RE: 647 N. Santa Cruz Avenue

I reviewed the drawings, and evaluated the site context. My comments and recommendations are as follows:

MULTIFAMILY STRUCTURE

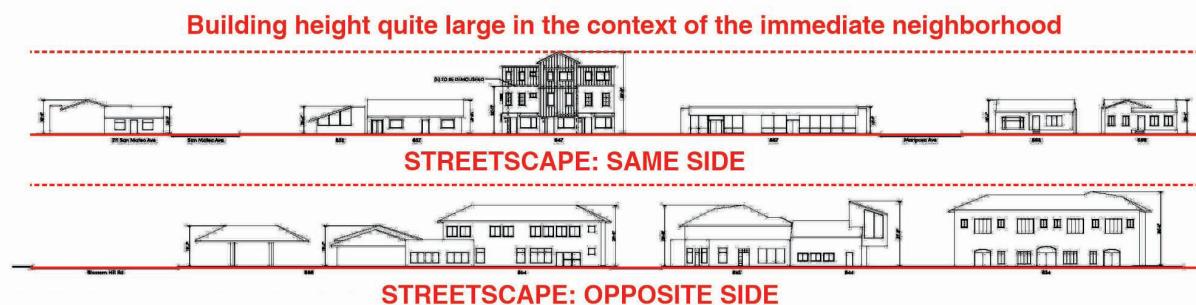
1. The proposed building height is larger than others along the street including the commercial buildings across North Santa Cruz Avenue. This would not be consistent with Residential Design Guideline 3.3.2.

2. The gable form superimposed over a flat box is not well designed, does not relate to the immediate neighborhood and would not be consistent with Residential Design Guideline 3.2.1.

Gable form superimposed on a flat box is not a well integrated design and would not be consistent with Residential Design Guideline 3.2.2

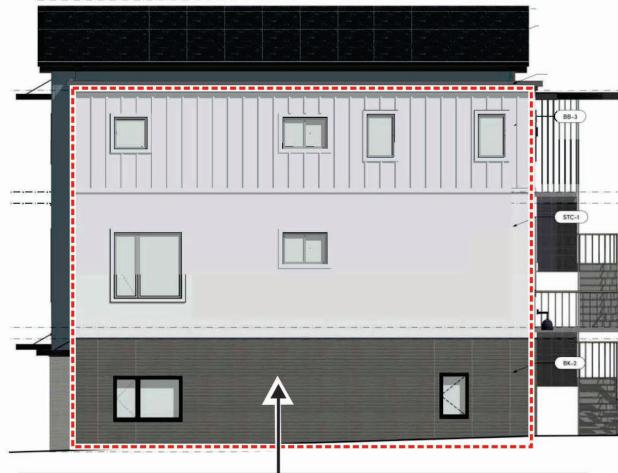
3. Window styles, proportions and details are not consistently articulated and would not be consistent with Residential Design Guideline 3.7.1, 3.7.2 and 3.7.4.

Windows are not well integrated and consistent

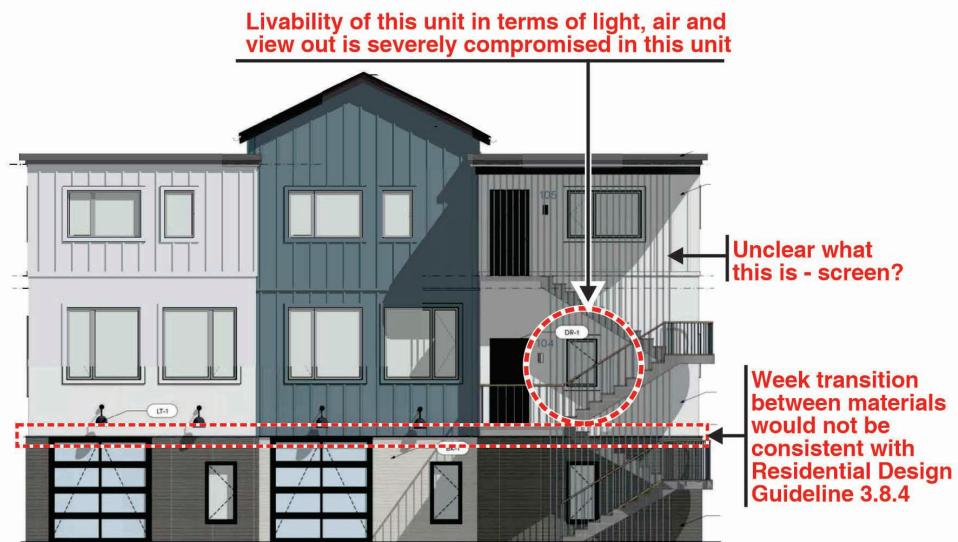
5. The transitions between facade materials is not well detailed and would not be consistent with Residential Design Guideline 3.8.4.

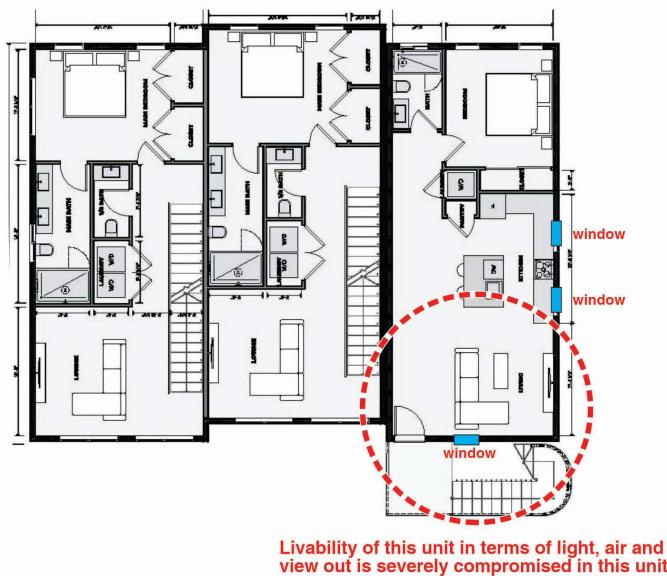
6. The livability of the second floor unit accessed by a stairway at the rear of the building would be severely compromised in terms of access to light and air with limited windows.

SINGLE FAMILY DETACHED HOMES

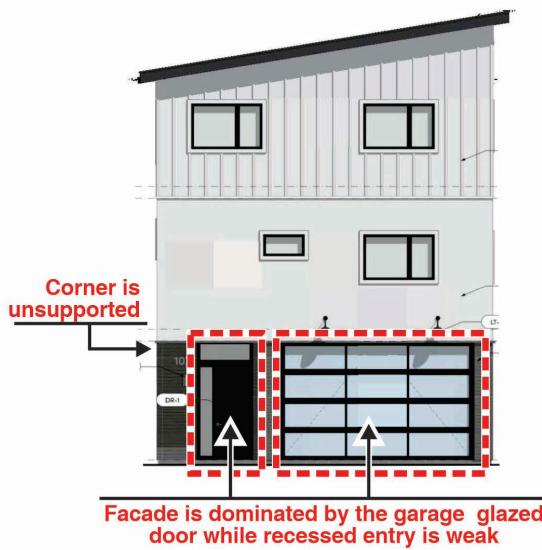
1. The first floor facades are dominated by the garage doors, made more prominent by what appears to be translucent glazing, while the recessed entries diminishes the sense of home entry which would not be consistent with Residential Design Guidelines 3.4.1 and 3.6.1.

- Note that the two story facade over the recessed entry appears to be unsupported except by a potential structural cantilever.
- 2. The transitions between facade materials is not well detailed and would not be consistent with Residential Design Guideline 3.8.4.

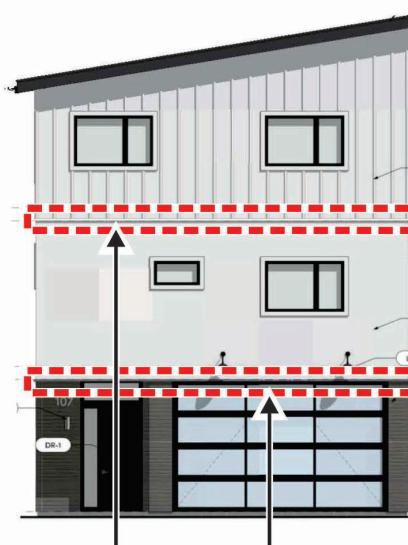
Transitions between floors and materials changes are weak and not consistent with Residential Design Guideline 3.8.4

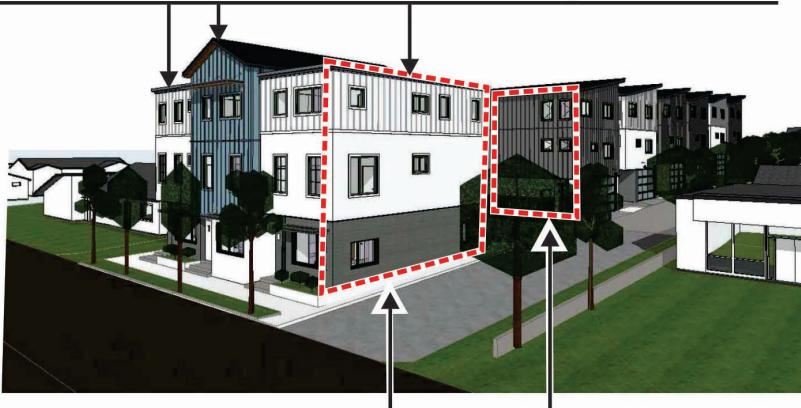
Gable form superimposed on a flat box is not a well integrated design and would not be consistent with Residential Design Guideline 3.2.2

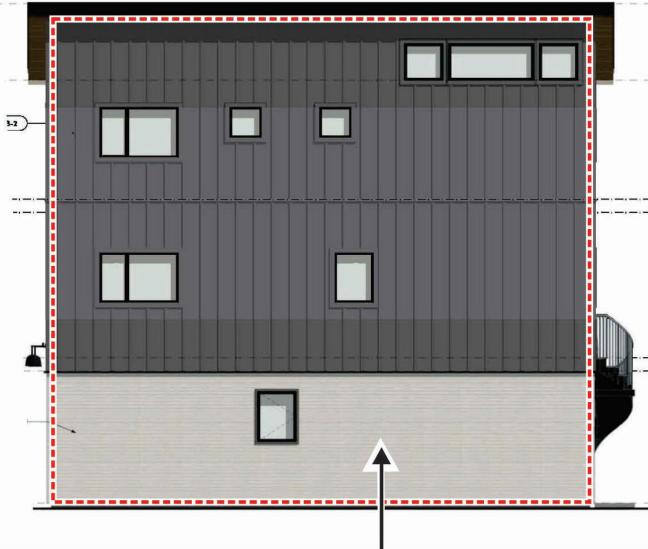
Two story wall is a poor edge to the entry drive and auto court and they would not be consistent with Residential Design Guideline 3.3.3

Two story plus wall is a poor edge to the auto court and would not be consistent with Residential Design Guideline 3.3.3
